Department  
for Transport

# AEBS 4<sup>th</sup> Meeting

## UK Position Paper

AEBS-03-08 extract

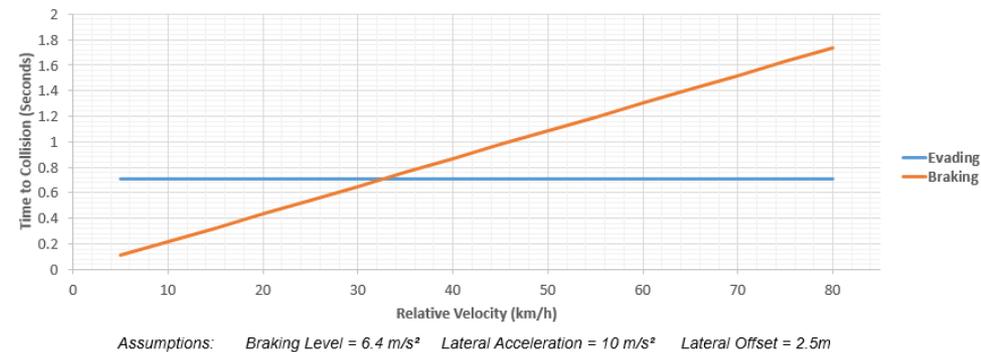
- ▶ Industry presented the concept of LPB and LPS at the 2<sup>nd</sup> AEBS meeting as part of the paper AEBS-02-05. In this paper, a lateral deceleration value of  $5\text{m/s}^2$  was applied.
- ▶ The latest industry paper (AEBS-03-08) used a value of  $10\text{m/s}^2$  for lateral acceleration in the LPS / LPB calculation.
- ▶ The UK is unclear on the driver behind this change.

## Adverse Weather Considerations

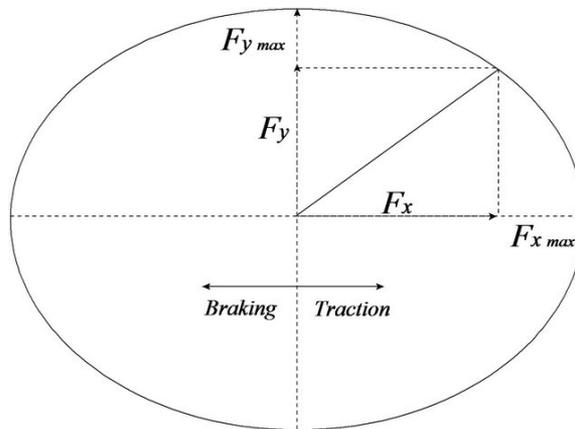
- ▶ The ACSF IWG recently concluded an appropriate deceleration value for wet concrete of  $3.7\text{m/s}^2$ . This equates to using all the available grip in one direction.
- ▶ In emergency manoeuvring situations, it is likely that the driver will apply both braking and steering inputs. Based on the adhesion ellipse below, the available grip will need to be distributed between longitudinal and lateral deceleration. Therefore, calculations for LPS & LPB in adverse weather conditions cannot both be based on the maximum value of  $3.7\text{m/s}^2$ .

- ▶ The UK recommends that the group consider AEBS operation in adverse weather by applying the maximum deceleration value of 3.7m/s<sup>2</sup> agreed within the ACSF IWG whilst also being cognisant of the need to share traction between longitudinal and lateral forces.
